TO: Kristopher Apanian, TAIT & Associates, Inc.
FROM: Amber Wood Hicken, Planner I
DATE: 4/10/25
SUBJECT: Parker Pointe, Auto Parts Store, Site Plan
Review Comments 01

PROJECT:
NEW O'REILLY AUTO PARTS STORE
STROH RD
PARKER, CO #2
SITE DEVELOPMENT PLAN

1 SITE DEVELOPMENT PLAN

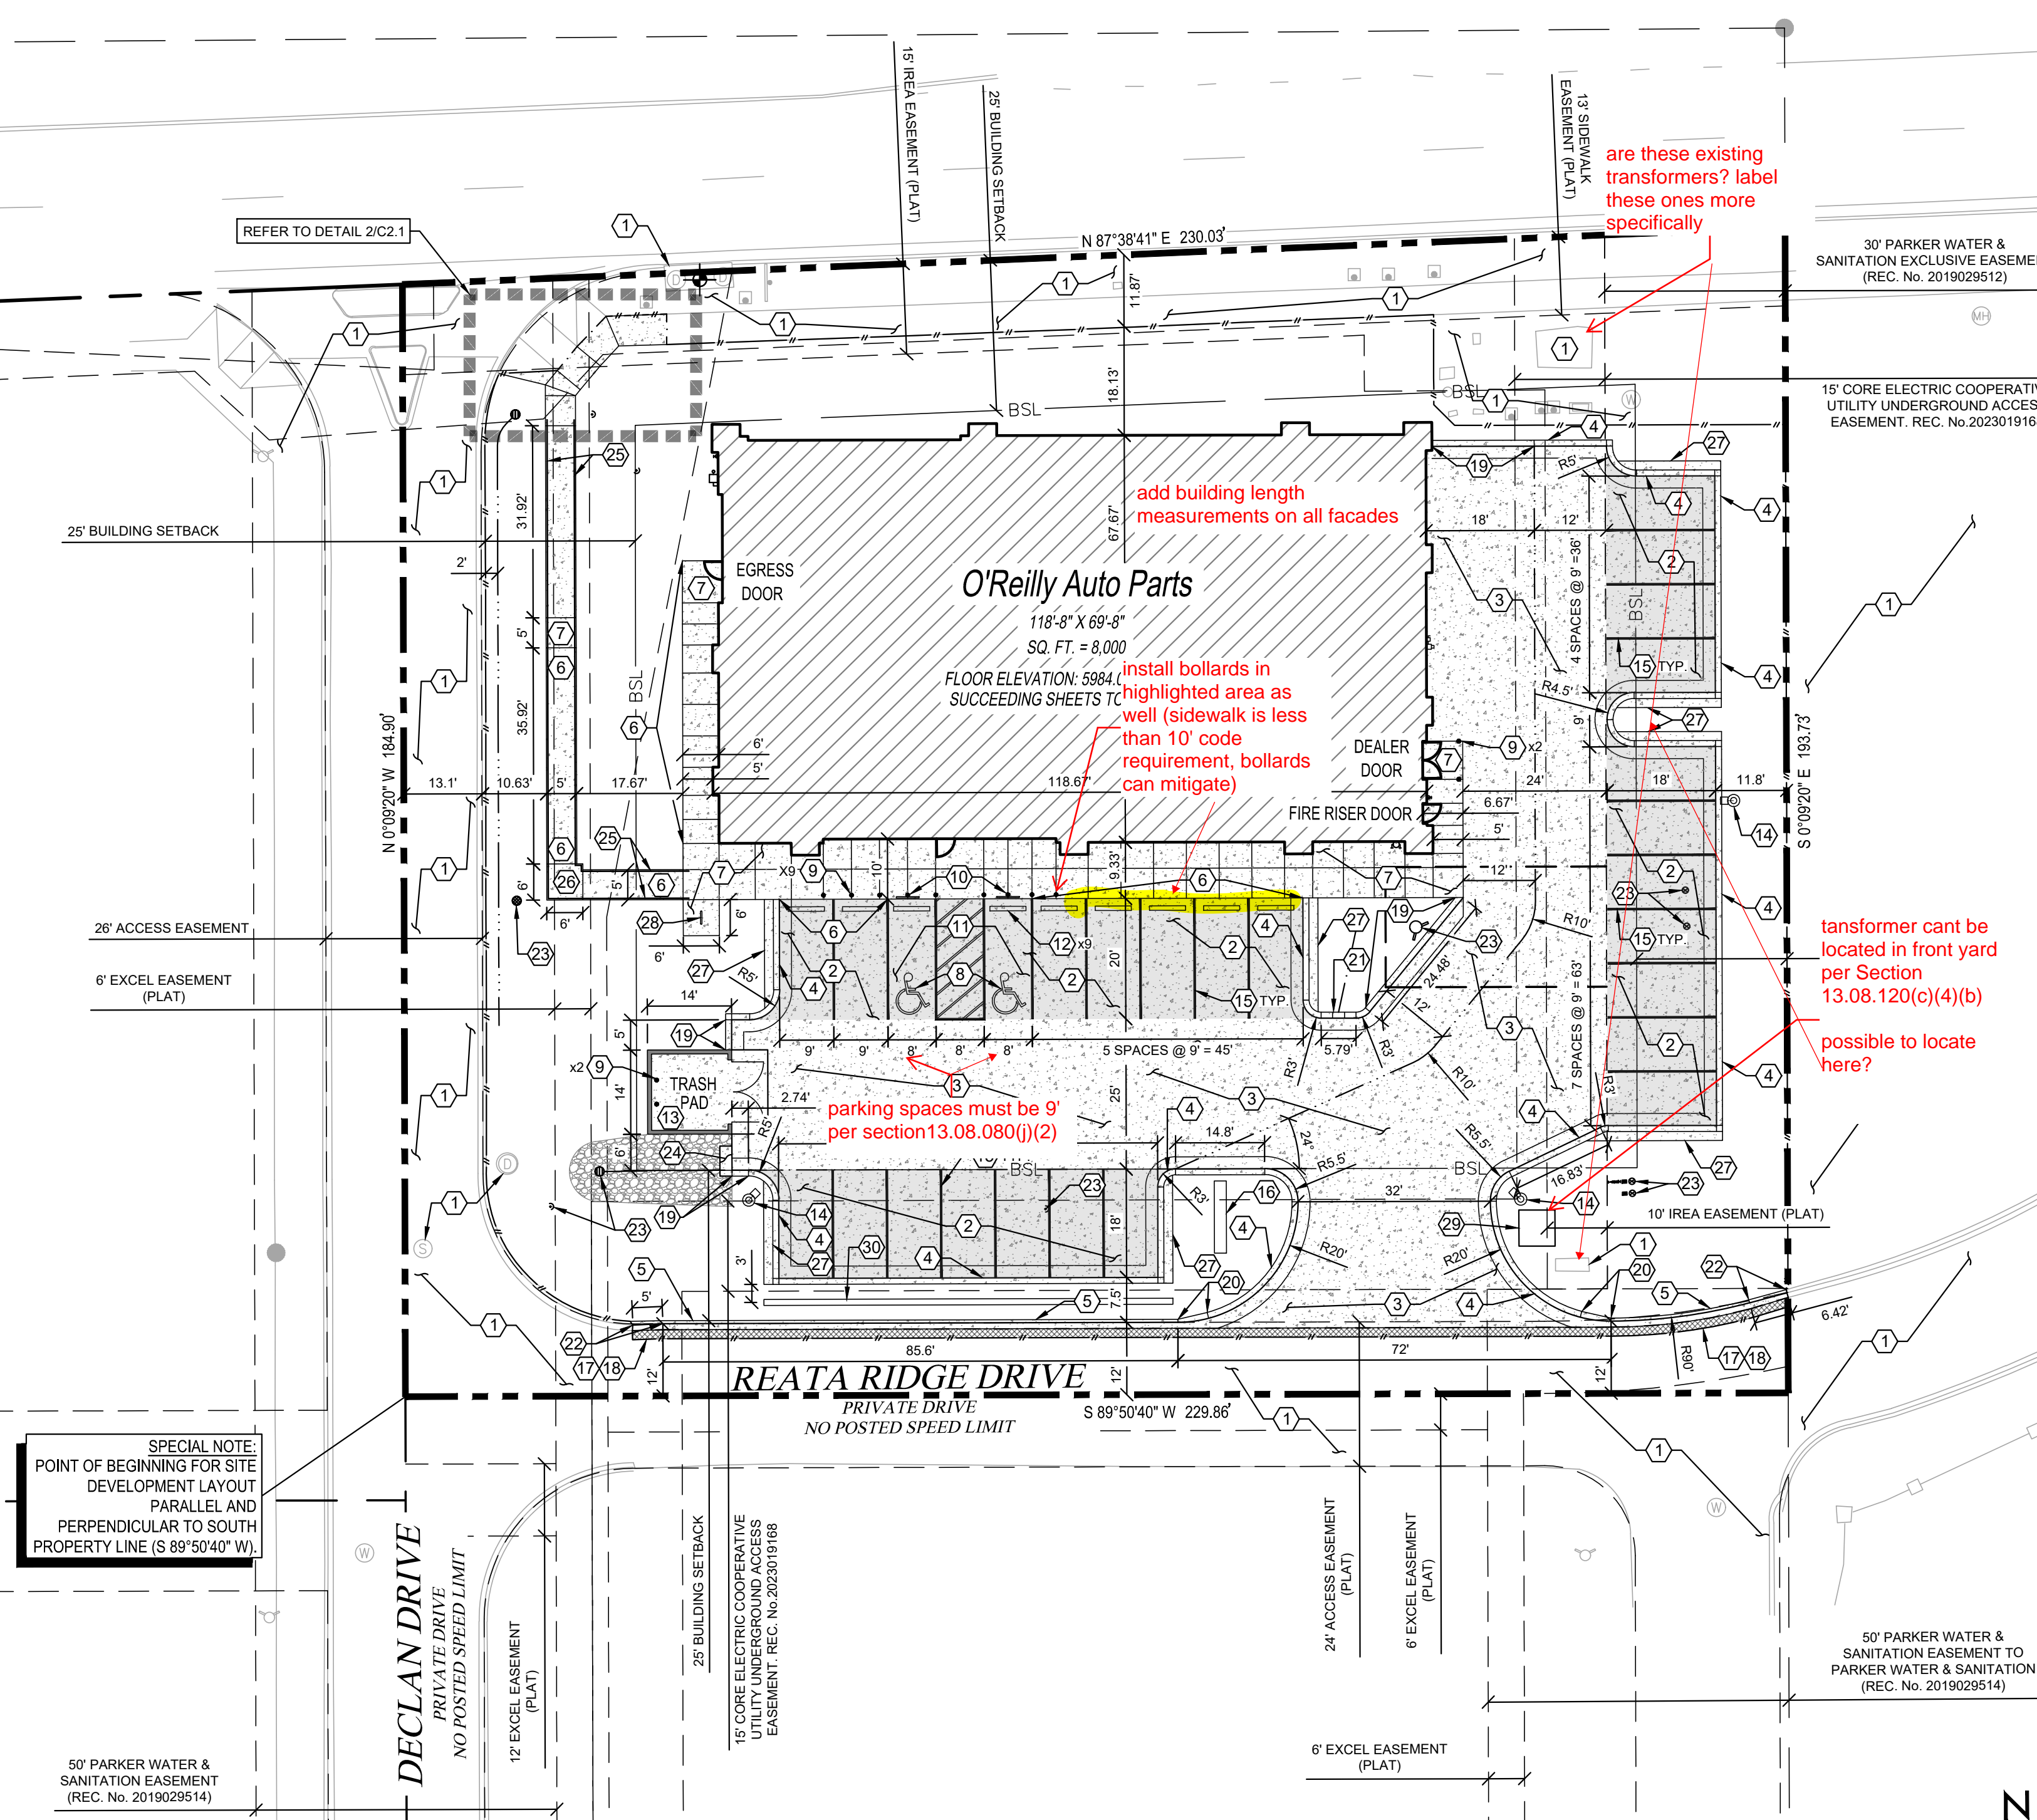
cover sheet needed. see LDO administrative manual for requirements.

provide total building setbacks from all property lines to building

are these existing transformers? label these ones more specifically

add building length measurements on all facades

install bollards in highlighted area as well (sidewalk is less than 10' code requirement, bollards can mitigate)

parking spaces must be 9' per section 13.08.080(j)(2)

transformer cant be located in front yard per Section 13.08.120(c)(4)(b)
possible to locate here?

provide specs for bollards. image, color

add note - monument signs will not be approved as part of this site plan. approved under separate permit.

1 LANDSCAPE PLAN

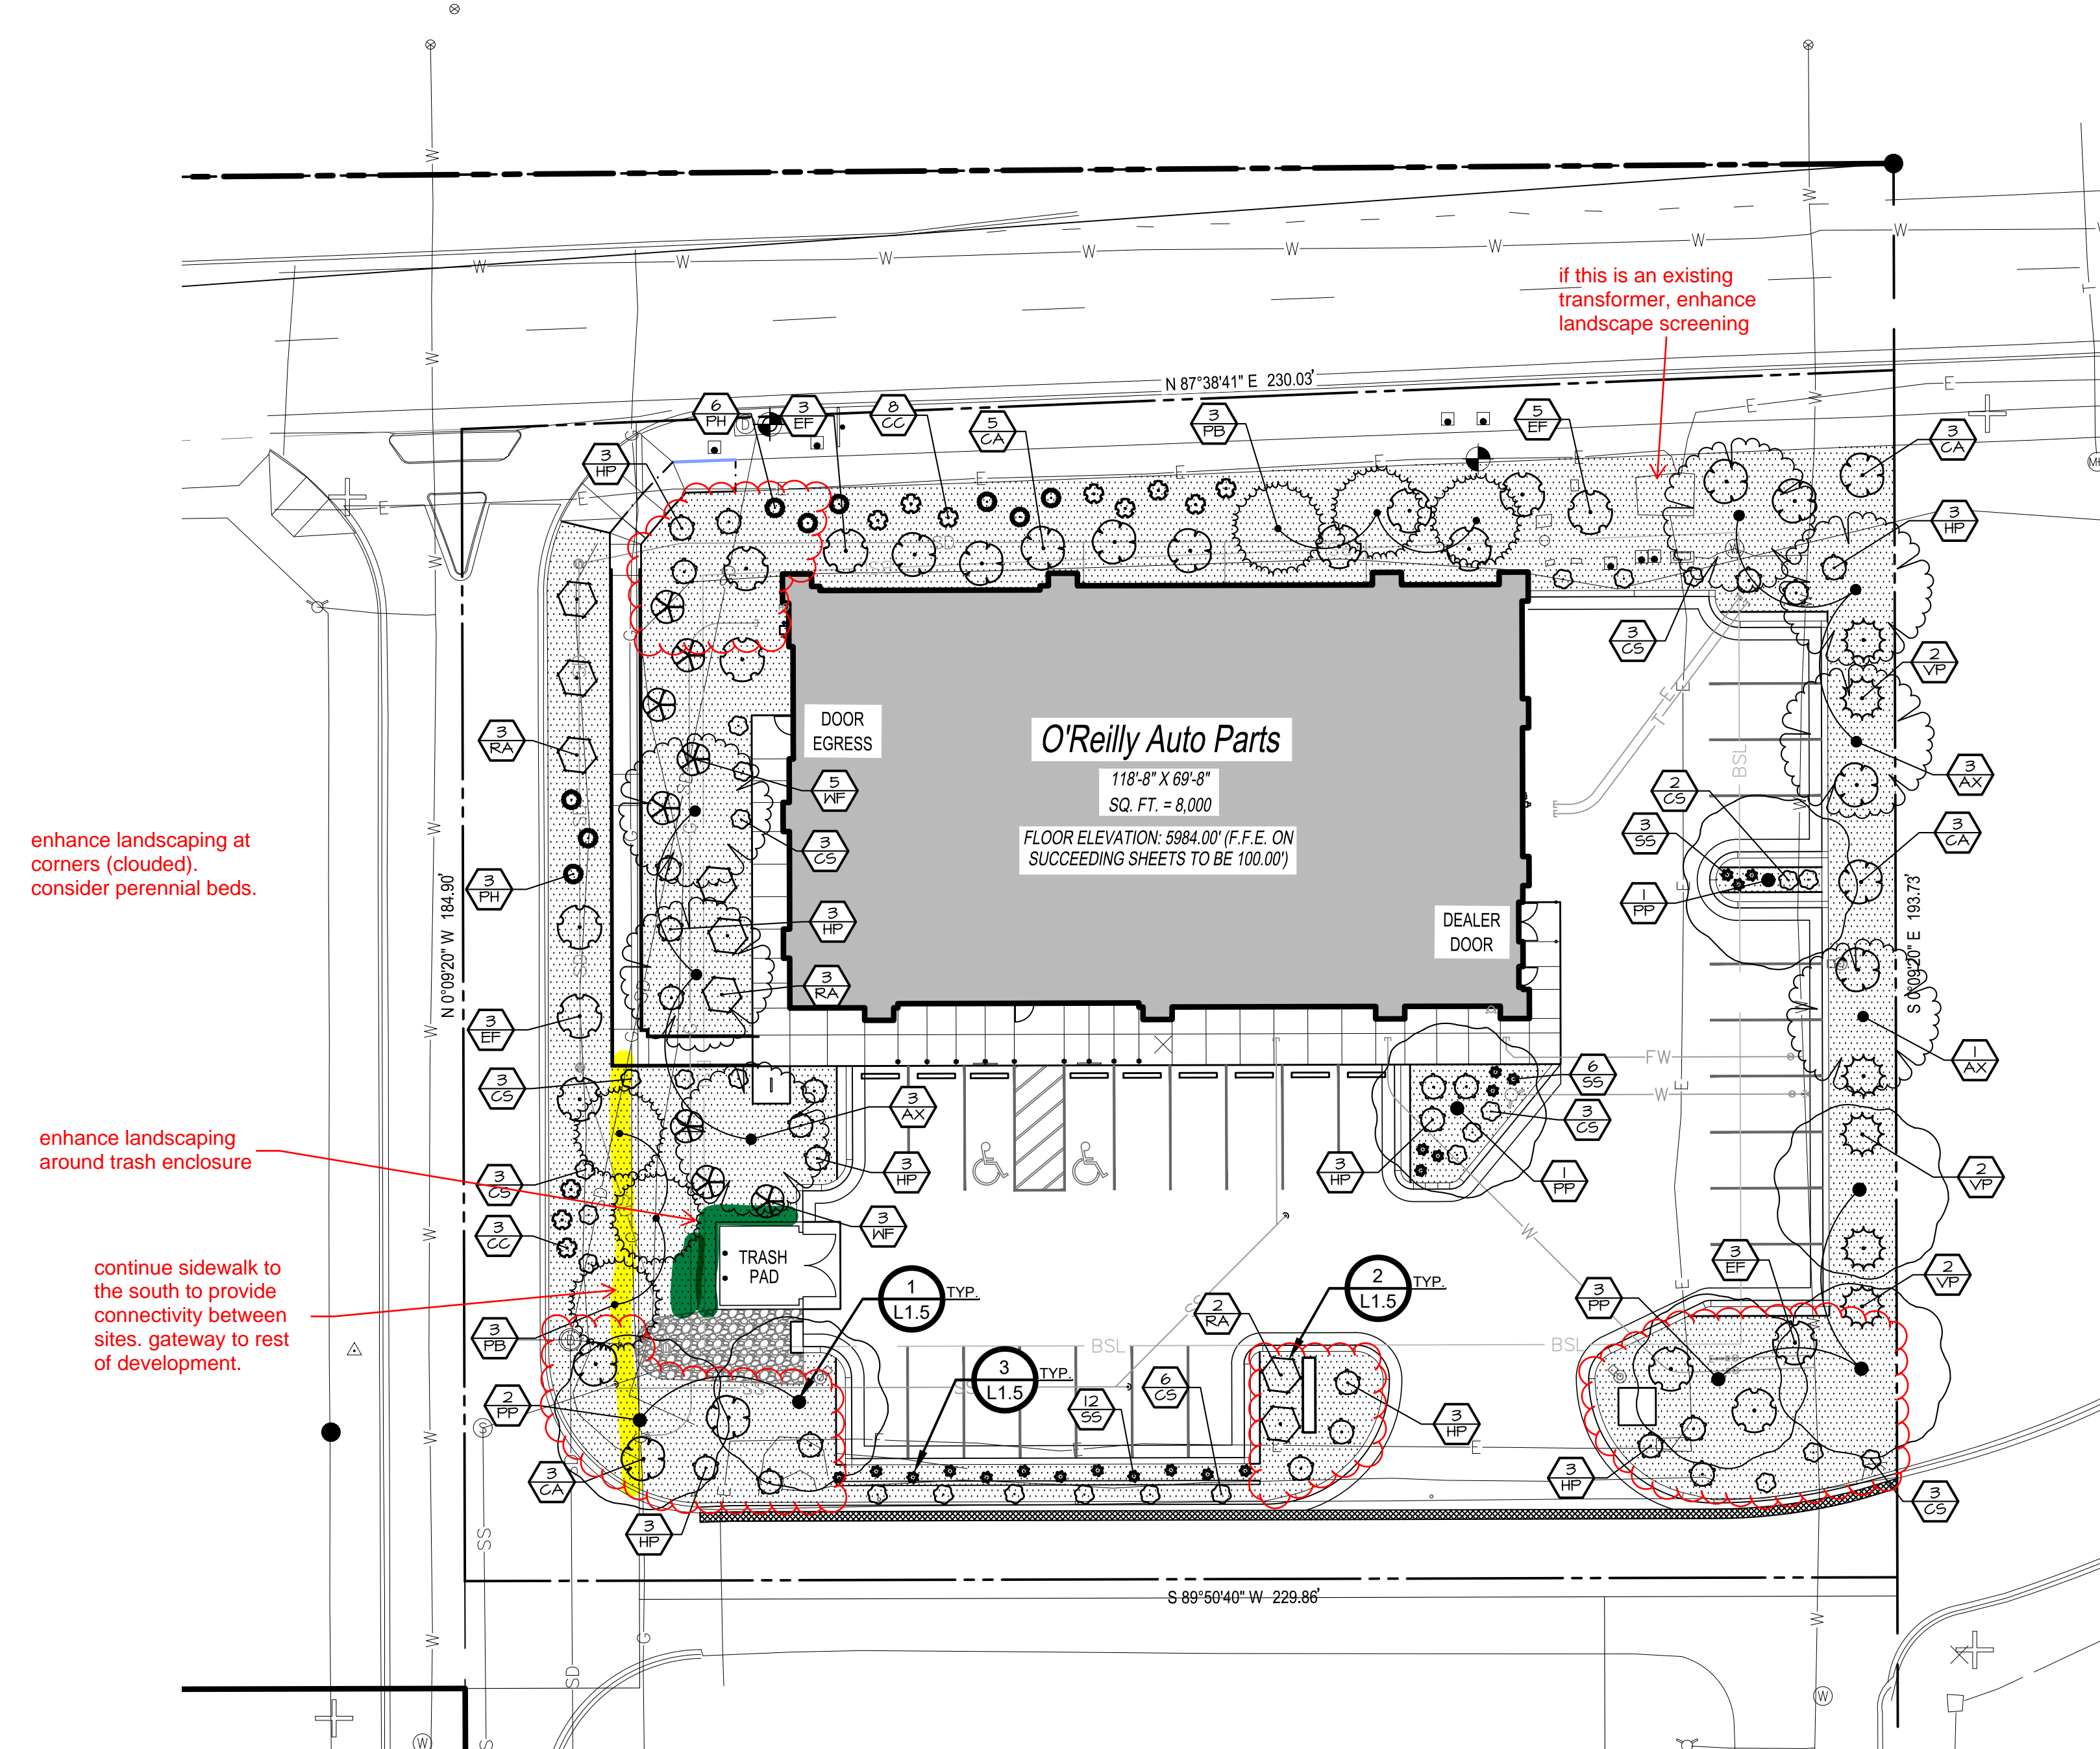
enhance landscaping at corners (clouded), consider perennial beds.

enhance landscaping around trash enclosure

continue sidewalk to the south to provide connectivity between sites, gateway to rest of development.

if this is an existing transformer, enhance landscape screening

break out islands, show square footage & planting requirements for each

break out each property line. P1 landscaping applies to north, east, west, & a portion of south. P2 applies to portion of south property line with parking

show that requirements are met:

1 tree, 5 shrubs per 1,500sf of lot area not covered by building or required parking

15% of developed area must be landscaped (show percentage & square footage)

75% of required landscaping must be live cover (show percentage & square footage)

2 EAST EXTERIOR ELEVATION

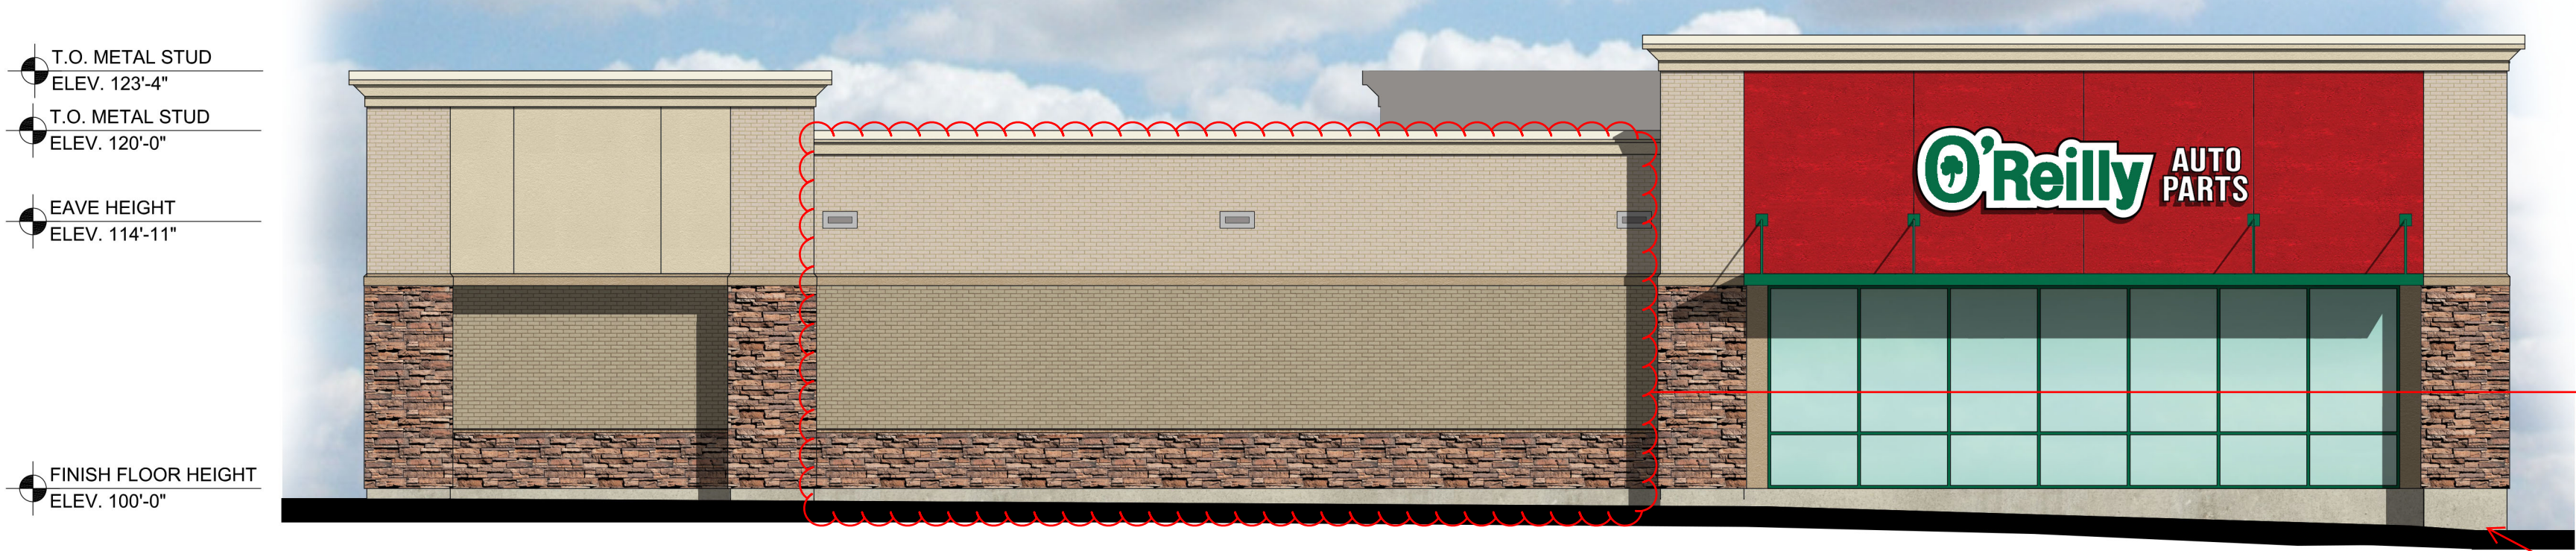
transparency requirements apply

this side will be visible from stroh. add some elements from other facades (red, green, canopy/eyebrow)

label. add note that electrical equipment will be painted to match adjacent wall, show as tan/brown on renderings

label. add note that pipes/meter will be painted to match adjacent wall, show as tan/brown on renderings
